U.S. Department
of Transportation
**Federal Highway
Administration**

In Reply Refer To:
HSST-1/B-136A

- ACRYLITE Soundstop TL-4 Noise Barrier System

TITLE: HORIZONTAL RAIL POST CONNECTION	PROJECT NO: 16P0007	FILE NAME: 16P0007-TL4 Modifications	 VISION BUILT
	PROJECT: TL-4 MODIFICATION DRAWINGS FOR FHWA APPROVAL	DRAWN BY: MJR	
	CHECKED BY: GJS	REVISED:	DWG. NO: SK-1

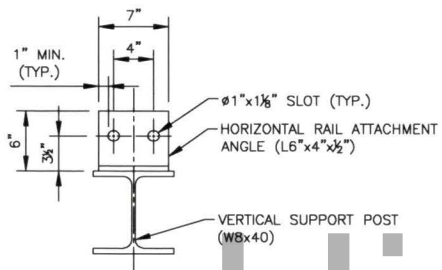
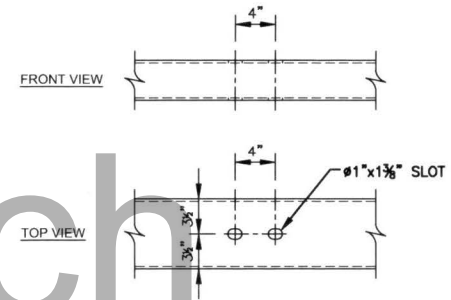
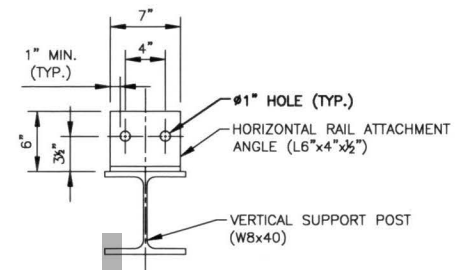
Modification benefits fabrication and on-site assembly. Affects connection of horizontal rails to posts. Submitted system utilized 1" x 1-1/8" slotted holes in the angles to which the rails attach and 1" x 1-1/8" slotted holes in the horizontal rails. Proposed modifications are:

- 1) Use 1" diameter holes in angles to which the rails attach in lieu of 1" x 1-1/8" slotted holes;
- 2) Use 1" x 1-3/8" slotted holes in the horizontal rails, increased from 1" x 1-1/8" slotted holes.

TITLE: ANCHOR ARRANGEMENT	PROJECT NO: 16P0007	FILE NAME: 16P0007-TL4 Modifications	 VISION BUILT
	PROJECT: TL-4 MODIFICATION DRAWINGS FOR FHWA APPROVAL	DRAWN BY: MJR	
	CHECKED BY: GJS	REVISED: APRIL 13, 2016	DWG. NO: SK-2

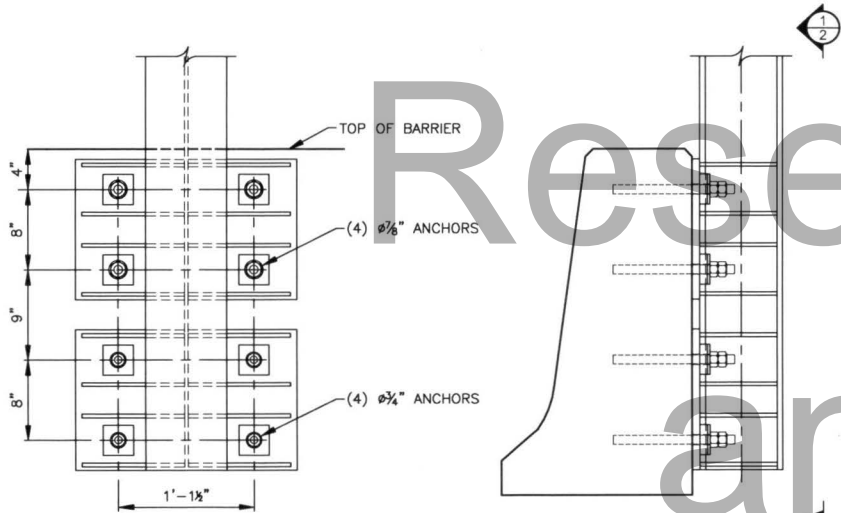
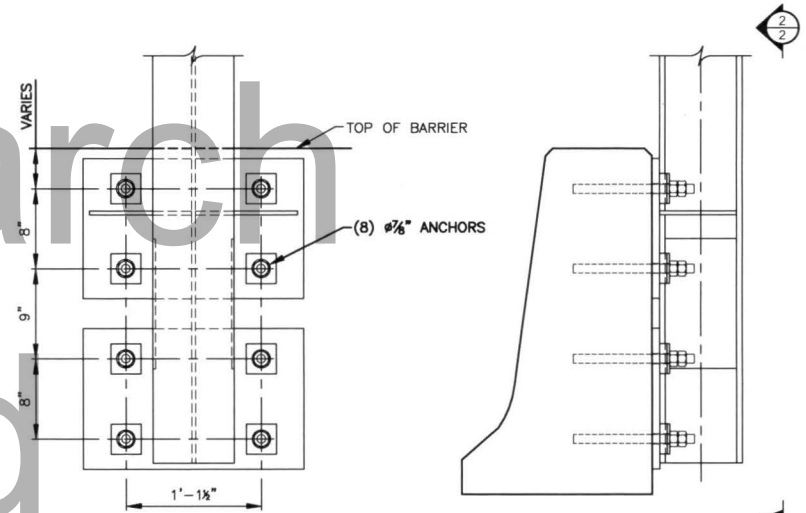
Modification to help error proof installation and simplify supply. Affects the eight epoxy set anchors connecting the vertical posts to the concrete parapet. Submitted system utilized four 7/8" diameter anchors for the upper anchorage plate and four 3/4" diameter anchors for the lower anchorage plate. Proposed modification is to replace the 3/4" diameter anchors for the lower anchorage plate with 7/8" diameter anchors. Result is a net improvement in the connection to the concrete parapet.

TITLE: ACRYLITE MOUNTING	PROJECT NO: 16P0007	FILE NAME: 16P0007-TL4 Modifications	 VISION BUILT
	DRAWN BY: MJR	DATE: APRIL 5, 2016	
PROJECT: TL-4 MODIFICATION DRAWINGS FOR FHWA APPROVAL	CHECKED BY: GJS	REVISED: JUNE 3, 2016	DWG. NO: SK-3

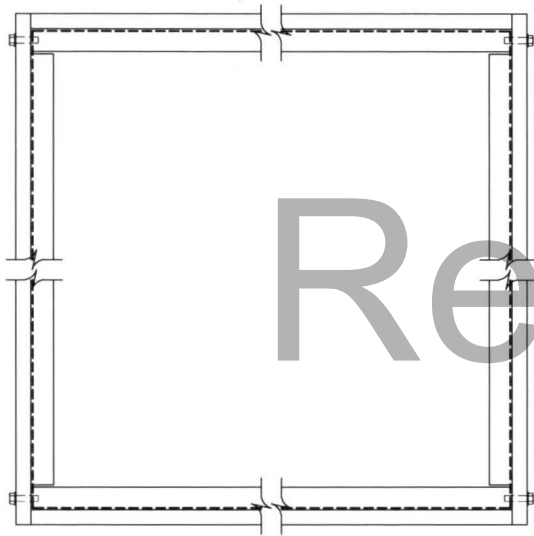
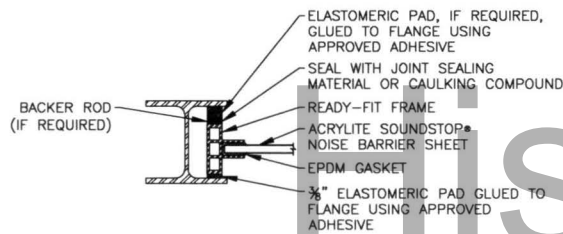
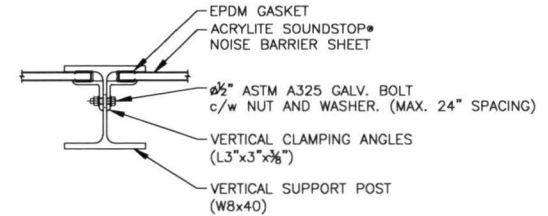
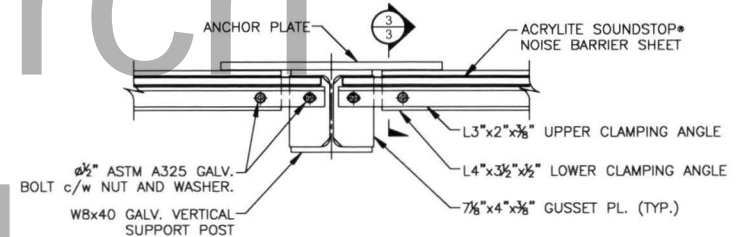
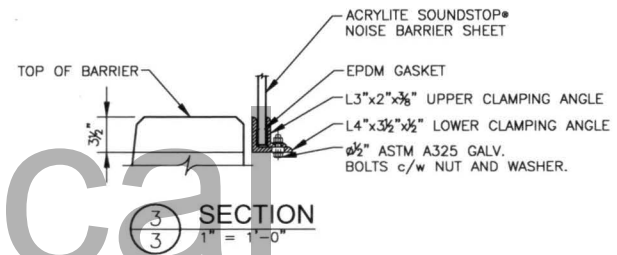
Modification to reduce snag potential of vehicle components versus the crash tested configuration. Affects the implementation of the noise barrier panels within the posts, behind the crash rails. Submitted system utilized framed noise barrier panels with anti-intrusion cover plates to minimize snag potential of peripheral vehicular components which might protrude in beyond the 7" wide x 4" high horizontal crash rails.

Proposed modification is to replace the framed noise barrier panels which produce an approximate 2.5" offset from the post flange to the noise barrier panel surface with 'unframed' noise barrier panels installed flush to the inside face of the post flange. Support for unframed noise barrier panels is provided by steel angles attached to the post web for the vertical noise barrier panel edges and a paired angle connection spanning a gusset plate inside the post for the bottom noise barrier panel edge. Effect of this modification is thought to be a net improvement to / reduction of the snag potential and irrelevant to the crash tested nature of the system since the noise barrier panels reside behind the horizontal crash rails which (along with the concrete parapet) bear the vehicular impact. Vehicular components which may extend beyond the crash rails have little impact value and any snag potential of such protrusion is reduced by this modification.

TITLE: SPLICE CONNECTION	PROJECT NO: 16P0007	FILE NAME: 16P0007-TL4 Modifications	 VISION BUILT
	PROJECT: TL-4 MODIFICATION DRAWINGS FOR FHWA APPROVAL	DRAWN BY: MJR	
	CHECKED BY: GJS	REVISED: APRIL 13, 2016	DWG. NO: SK-4

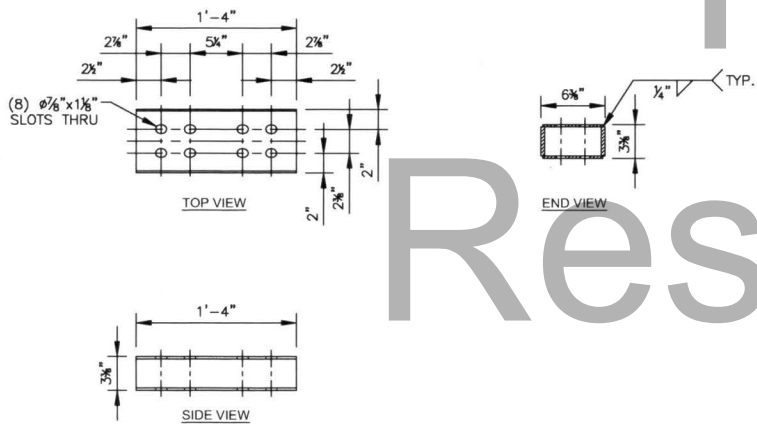
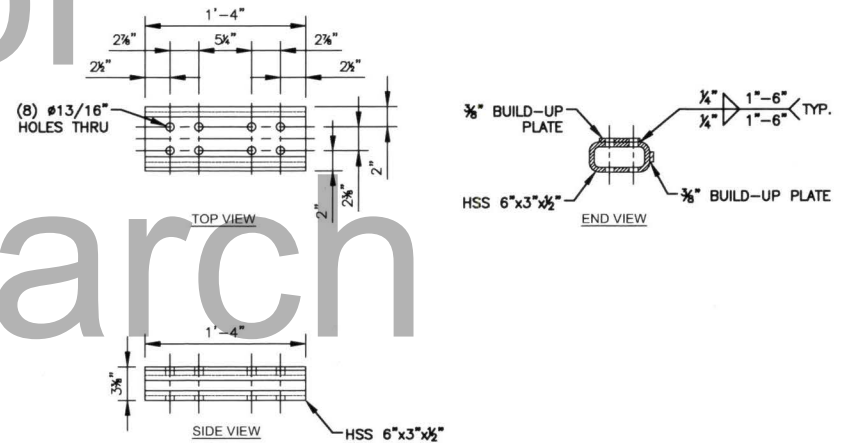
Modification to simplify the fabrication of splice sleeves and on site assembly issues. As originally designed the splice sleeves used to connect horizontal crash rails were constructed of four 1/2" thick steel plates welded together to make a tubular sleeve. The dimensions of the fabricated sleeve for the lower rail with 5/16" wall thickness are 6 1/8" x 3 1/8" x 16" (see attached detail). This leaves a planned 1/4" of fit space for both the width and the length.

Proposed modification is to replace fabricated splice sleeves with readily available 6" x 3" tube steel in the same 16" length. Tube sections for the lower rail with 5/16" wall thickness would create an additional 1/8" of fit space for both the width and length, an important feature since installations made with the fabricated sleeve have been subject to interference with the as produced weld seam inside the horizontal crash rails.

Splice sleeves for the middle and upper (3/16" wall thickness) horizontal crash rails would similarly be constructed of 6" x 3" x 16" tube steel segments but would also include welded plates on two sides to achieve a fit similar to the outgoing fabricated splice sleeve. See attached details, note gap between plates on bottom of 6" x 3" tube to avoid interference with weld seam inside horizontal crash rail.

Proposed splice sleeves use tube with 1/2" wall thickness and have greater structural strength than the fabricated sleeves. Result is a modification to benefit fabrication with no change to the crashworthiness of the system.

TITLE: VARYING PARAPET WALL DEPTHS	PROJECT NO: 16P0007	FILE NAME: 16P0007-TL4 Modifications	 VISION BUILT
	DRAWN BY: MJR	DATE: APRIL 5, 2016	
PROJECT: TL-4 MODIFICATION DRAWINGS FOR FHWA APPROVAL	CHECKED BY: GJS	REVISED: APRIL 13, 2016	DWG. NO: SK-5

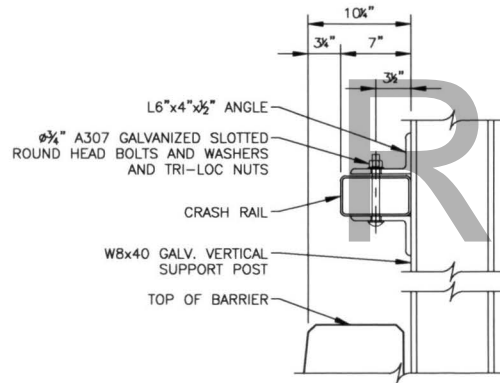
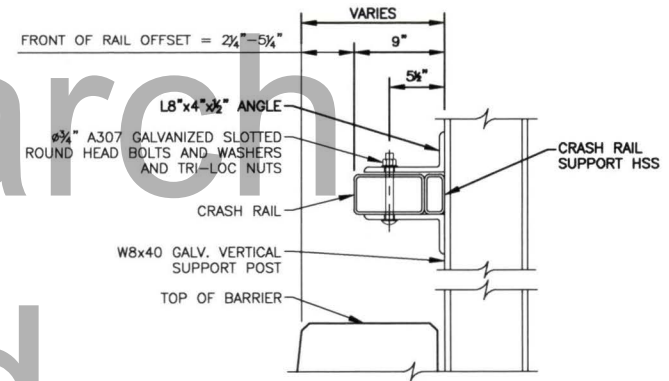
Modification for ACRYLITE Soundstop TL4 noise barrier system application on a thicker concrete parapet.

As tested, the parapet section was 9.5" thick at the top. The leading edge of the 7" x 4" horizontal crash rail is 3.25" behind the top corner (accounting for the 3/4" setback of the post due to the 3/4" anchorage plate).

In accordance with HSA-10/B-136, the ACRYLITE Soundstop noise barrier system is acceptable for use on single slope, NJ, and F shape type parapets. However, parapets of different thicknesses can create a variable setback of the horizontal crash rails. In such cases, it is desirable to maintain a horizontal rail setback similar to the condition during the crash test.

- 1) allow the horizontal crash rail setback to range from plus 2" and minus 1" from the as-tested configuration. This results in an allowable range from 2.25" to 5.25" (for clarity it is noted this proposed change to the horizontal rail setback does not change the anchorage requirements. Any proposal for modification of anchorages would require a separate modification request);

- 2) in situations where the concrete parapet is substantially thicker than the as-tested parapet and to position the horizontal crash rails within the acceptable range by using strong tube supports between the horizontal crash rail and the vertical posts (reference Mod005 Weld Doc.pdf);

- 3) in situations where there are existing allowed noise barrier walls with a position that is closer to roadway than the allowable range of this system's horizontal crash rails, allow the leading edge of the horizontal crash rails to match the position of the existing allowed noise barrier wall (reference Mod005 Details View.pdf which shows this system in conjunction with a Caltrans approved Masonry wall system).

The primary requirement relating to the position of the crash rails is to avoid a scenario where a vehicle colliding with the parapet and ACRYLITE Soundstop TL4 noise barrier system would act differently than the as-tested condition. This is most likely to occur if a vehicle is allowed to roll more than the as-tested condition and thus act in a less predictable manner than if the rails are maintained close to the 3.25" as-tested setback location.

In the two cases where the rails would be moved slightly toward the roadway, vehicular roll would be slightly reduced versus that observed in the crash-tested condition. In this case, an increased chance of rail contact with a vehicle occupant in a head ejection scenario is acknowledged, but it is further noted that such consideration is outside the scope of the prior NCHRP 350 crash-test criteria.

In the case where the rails would be allowed to be positioned 2" farther back from the top corner of the parapet, vehicular roll would be slightly increased versus the as-tested condition but still expected to perform in a similar manner to the crash-tested condition.

TITLE:	EXPANSION JOINT SPLICE DETAILS	PROJECT NO:	16P0007	FILE NAME:	16P0007-TL4 Modifications	 VISION BUILT	
PROJECT:	TL-4 MODIFICATION DRAWINGS FOR FHWA APPROVAL	DRAWN BY:	MJR	DATE:	APRIL 5, 2016		
		CHECKED BY:	GJS	REVISED:	JUNE 6, 2016	DWG. NO:	SK-6

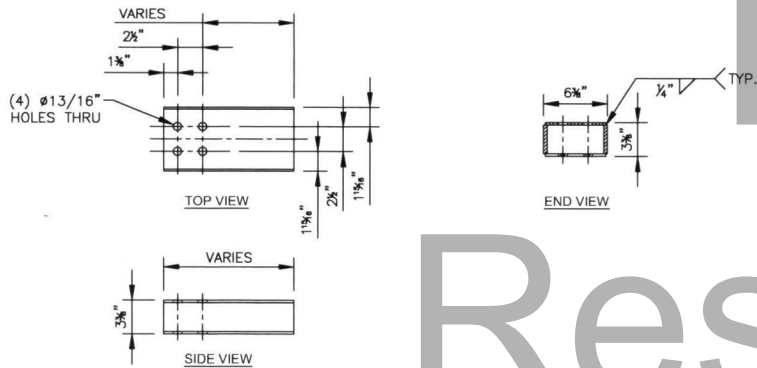
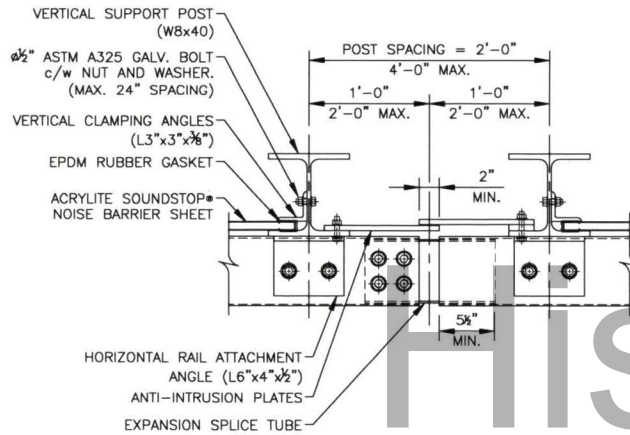
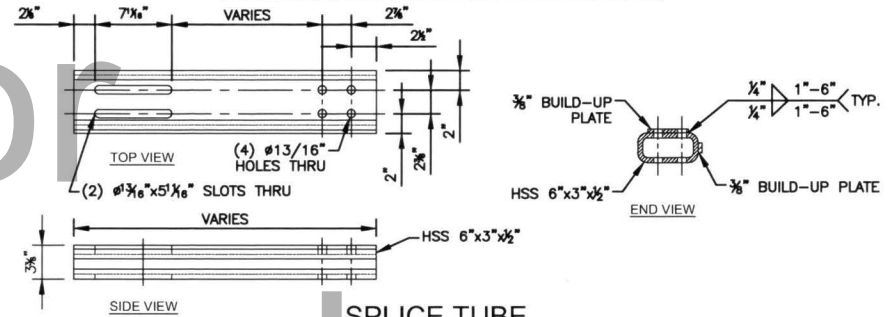
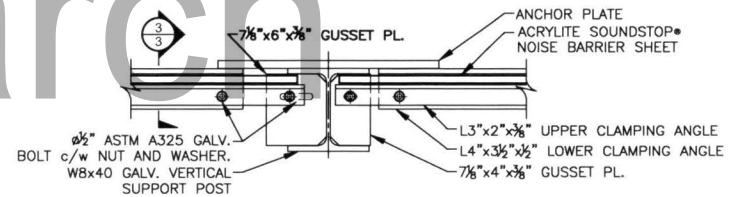
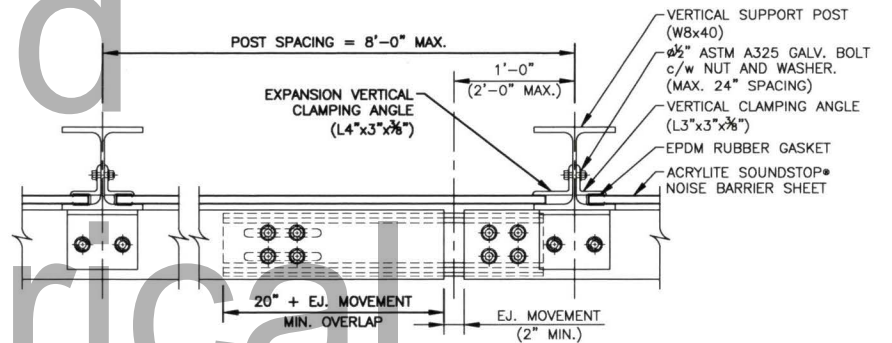
Modification for ACRYLITE Soundstop TL4 noise barrier system to increase the separation of posts at expansion bays. It is noted that the as-tested configuration did not include an expansion bay but, by necessity, expansion bay details were added to the submission culminating in approval HSA-10/B-136.

The expansion bay details per HSA-10B/B-136 included posts connected to the parapet on each side of the expansion joint. The posts are separated 24" from post center to post center, which positions the 22" wide post to parapet anchorage plates of these posts only 2" apart.

It is proposed to allow the space between posts spanning an expansion joint to increase from 24" to 96". The 96" dimension between posts would match the maximum span allowable for the ACRYLITE Soundstop TL4 noise barrier system per the HSA-10/B-136 approval. Details to include an ACRYLITE Soundstop panel in lieu of the polymeric expansion joint strip seal are provided in Mod006 proposed 8 ft expansion joint details.pdf.

The expansion joint includes a detail for splice sleeves in the horizontal crash rail to allow the intended expansion. This splice sleeve for the expansion bay is 16.5" long with eight 7/8" x 1 1/2" slots to connect the splice to the horizontal crash rails (see Mod006 expansion joint splice detail.pdf). It is noted that the splice is connected using 5/8" diameter bolts, which would allow a maximum range of movement of ± 1.75 ". In addition to the proposal to widen the expansion bay from 24" to 96", the following changes are also proposed for the expansion bay splice sleeves / connections:

- 1) When the expansion bay is 28" to 48" long, a 20" long splice tube with four 7/8" x 1-1/8" slots is to connect to one horizontal crash rail only, with no intended connection to the other horizontal crash rail other than a long inserted end, may be substituted for the existing (as-tested) 16.5" long splice sleeve with eight 7/8" x 1-1/2" slots intended to connect to both horizontal crash rail ends.
- 2) When the expansion bay is >48", up to 96" wide, a 20" long splice tube with eight 7/8" x 2" slots may be substituted for the 16.5" long splice sleeve with eight 7/8" x 1-1/2" slots. This longer rail would connect to both sides in the same manner as the 16.5" long splice but would allow for a maximum range of movement of 2.75".

CHECK WELDS

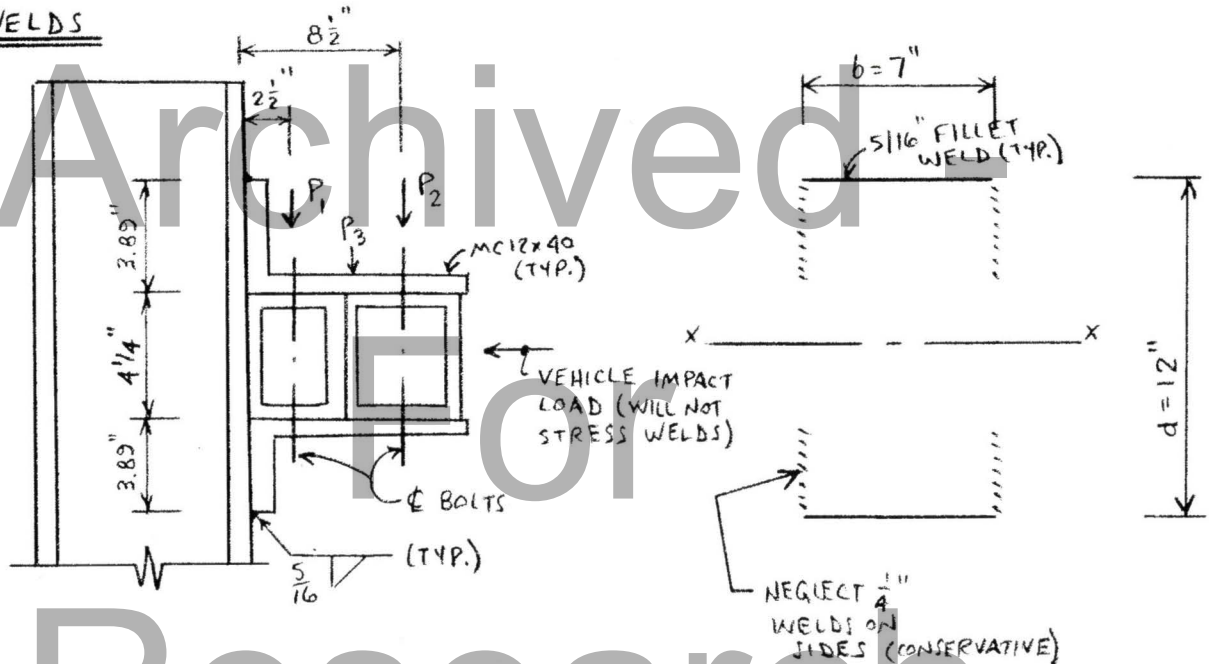
$$\begin{aligned}
 P_1 &= HSS 5 \times 4 \times 1/4 = 13.91 \text{ Lb/ft} \times 0.583' = 9 \text{ Lbs} \times 2.5'' = 77 \text{ LbIn} \\
 P_2 &= HSS 7 \times 4 \times 5/16 = 21.21 \text{ Lb/ft} \times 8' = 170 \text{ Lbs} \times 8.5'' = 1,445 \text{ LbIn} \\
 P_3 &= 2 \cdot MC12 \times 40 = 2 \times 40 \text{ Lb/ft} \times 0.583' = 47 \text{ Lbs} \times 6''(\pm) = 282 \text{ LbIn} \\
 P &= 226 \text{ Lbs} \qquad M = 1,804 \text{ LbIn}
 \end{aligned}$$

$$0.27 F_u = 0.27 \times 70 \text{ ksi} \times 0.707 \times 5/16'' = 4.18 \text{ k/in} \dots \text{AASHTO Eq. (10-12)}$$

$$\begin{aligned}
 S_w &= bd = 7'' \times 12'' = 84 \text{ in}^2 \dots \text{BLDGGETT, Table 5 (p. 74-7)} \\
 M/S_w &= 1804 \text{ LbIn} / 84 \text{ in}^2 = 21.5 \text{ Lb/in} \\
 P/A &= 226 \text{ Lbs} \div (2 \times 7'') = 16.2 \text{ Lb/in} \\
 R &= \sqrt{(21.5)^2 + (16.2)^2} = 27 \text{ Lbs/in} \\
 &\qquad \qquad \qquad \div 1000 \\
 &\qquad \qquad \qquad 0.03 \text{ k/in}
 \end{aligned}$$

$$0.03 \text{ k/in} \ll 4.18 \text{ k/in} \quad (\text{OK})$$

TITLE: LOWER RAIL PLACEMENTS FOR VARYING HEIGHT BARRIER WALL	PROJECT NO: 16P0007	FILE NAME: 16P0007-TL4 Modifications	 VISION BUILT
	PROJECT: TL-4 MODIFICATION DRAWINGS FOR FHWA APPROVAL	DRAWN BY: MJR	
	CHECKED BY: GJS	REVISED: JUNE 16, 2016	DWG. NO: SK-7

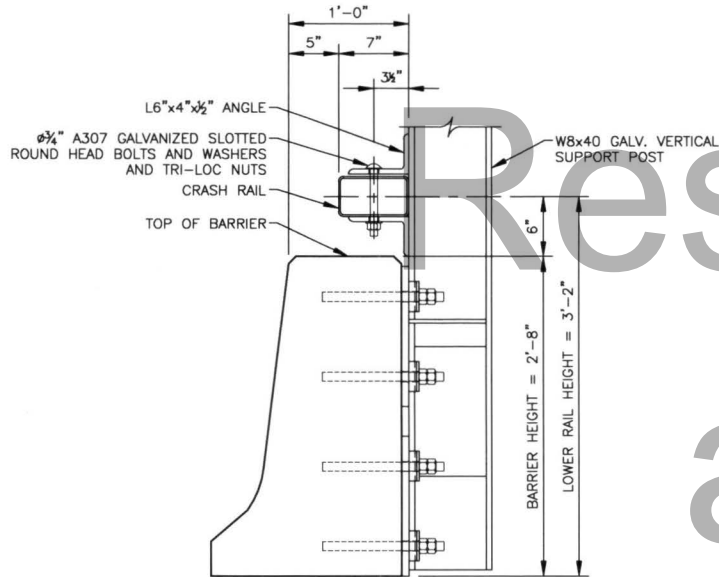
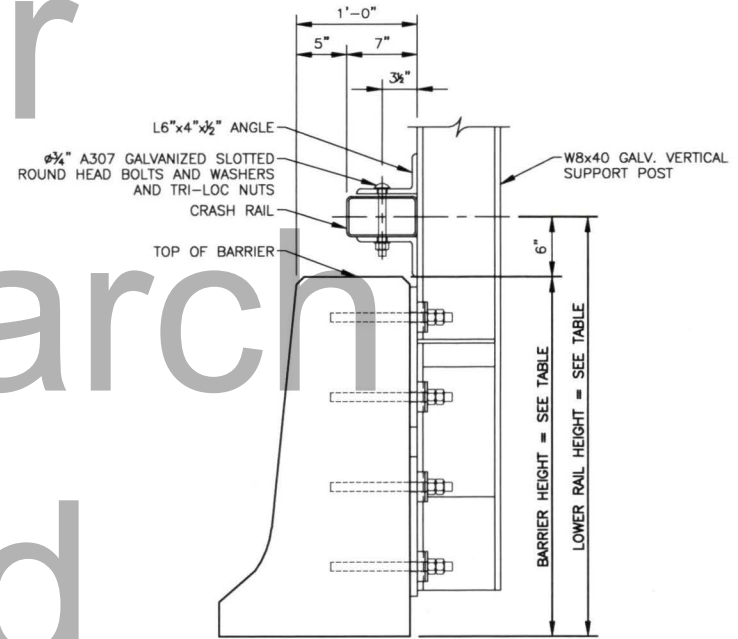
The ACRYLITE Soundstop TL4 noise barrier system was crash tested on a 32" high single slope concrete parapet. with horizontal crash rails at 38", 60", and 128". Horizontal crash rail locations are measured from top of deck to the center of the 4" high vertical face of a particular horizontal crash rail. The intent of the horizontal crash rails are to bear contact and safely redirect the vehicle to prevent substantial impact and snag with the vertical posts and panels.

With the bottom rail centered at 38", the traffic facing surface of this rail vertically extends from 36" to 40" with 4" of clearance between the lowest edge of the rail and the top of the parapet (less considering the attachment angle below the rail). Due to potential interference between the attachment angle and the concrete parapet it is necessary to maintain the 4" clearance from the top of the parapet for parapets that are taller than the 32" high as-tested parapet. When the parapet height however reaches 40", the same height as the top surface of the lowest rail as-tested, the lowest rail may be omitted.

32" high parapet (as-tested), lowest rail centered at 38"

34" high parapet, lowest rail centered at 40"

36" high parapet, lowest rail centered at 42"

38" high parapet, lowest rail centered at 44"

40" high parapet, minimum parapet height where lowest rail not required.

TITLE:	PROJECT NO:	FILE NAME:	 armtec VISION BUILT
UPPER RAIL HEIGHT FOR VARYING HEIGHT OF TL-4 BARRIER	16P0007	16P0007-TL4 Modifications	
PROJECT:	DRAWN BY:	DATE:	
TL-4 MODIFICATION DRAWINGS FOR FHWA APPROVAL	MJR	APRIL 5, 2016	
	CHECKED BY:	REVISED:	DWG. NO:
	GJS	APRIL 13, 2016	SK-8

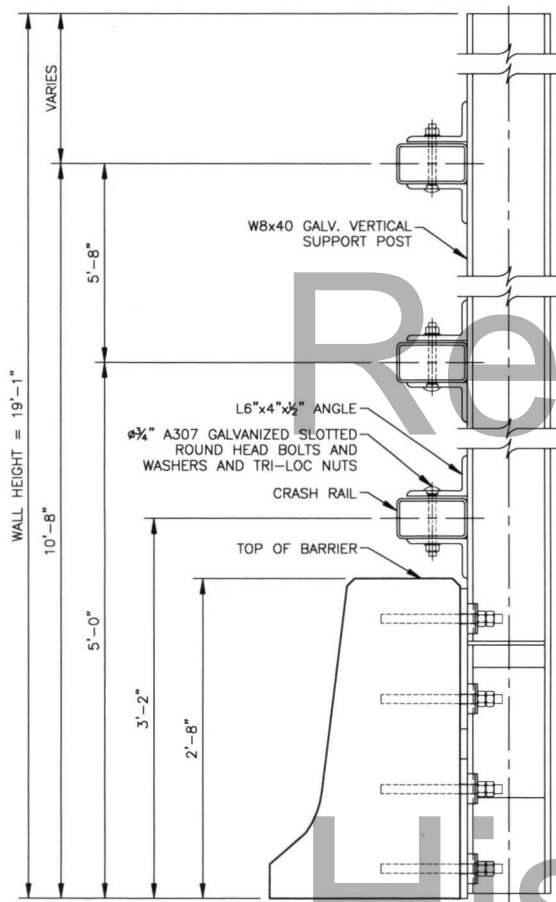
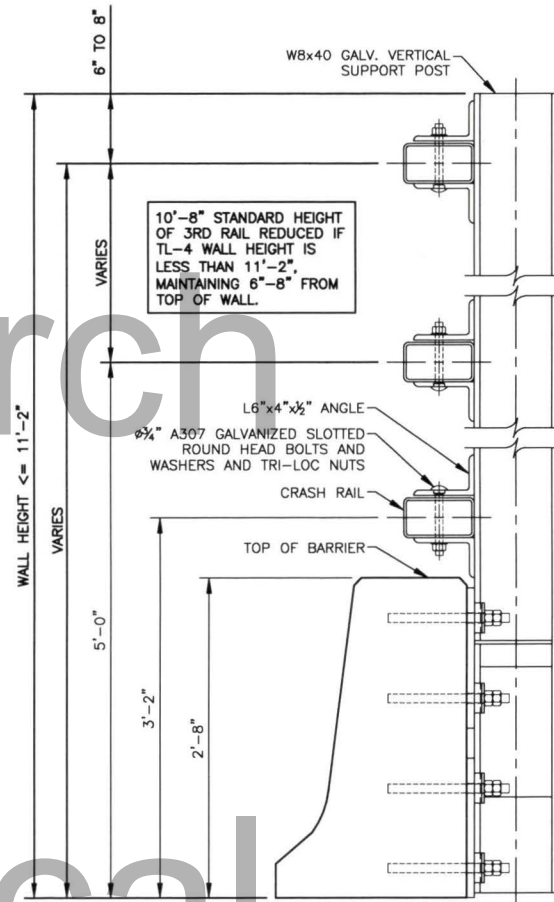
The ACRYLITE Soundstop TL4 noise barrier system was crash tested on a 32" high single slope concrete parapet with with horizontal crash rails at 38", 60", and 128". Horizontal crash rail locations are measured from top of deck to center of 4" high vertical face of horizontal crash rail. The overall tested height was 229" inches (19'-1"). The intent of the horizontal crash rails are to bear contact and safely redirect the vehicle to prevent substantial contact and snag with the vertical posts and panels.

Shorter overall heights are allowable and straightforward when the overall wall height remains high enough to position the uppermost horizontal crash rail at the as-tested position of 128". Note that the minimum overall wall height including the uppermost horizontal crash rail centered at 128" is 135" (+7"), which includes the upper half of the 4" high rail plus 5" for attachment of the horizontal crash rail support angle.

The 5" extension of the post beyond the top edge of the 7" wide horizontal crash rail creates an angle of 54.5 degrees from the top of the horizontal crash rail to the top of the post (reference attached Mod008 sketch.pdf). This is noteworthy as it would require an extreme vehicular lean to create contact with the section of post above the horizontal crash rail.

Wall heights shorter than 135" require that the uppermost crash rail be moved down yet maintained at the top of wall, specifically 7" from top of wall to the center of the uppermost horizontal crash rail. This is acceptable as the uppermost rail is still expected to prevent substantial vehicular contact with the posts, as intended.

The uppermost horizontal crash rail may be moved down from the crash-tested position of 128" (overall height of 135") to a minimum height of 70" (overall height of 77"). Lowering this horizontal crash rail any farther would result in interference with the horizontal crash rail centered at 60".

For wall heights shorter than 77" overall, it is acceptable to omit the uppermost horizontal crash rail while maintaining the horizontal crash rail centered at 60". This results in an overall wall height of 67". Wall heights less than 67" as well as wall heights between 67" and 77" are not considered by this request.
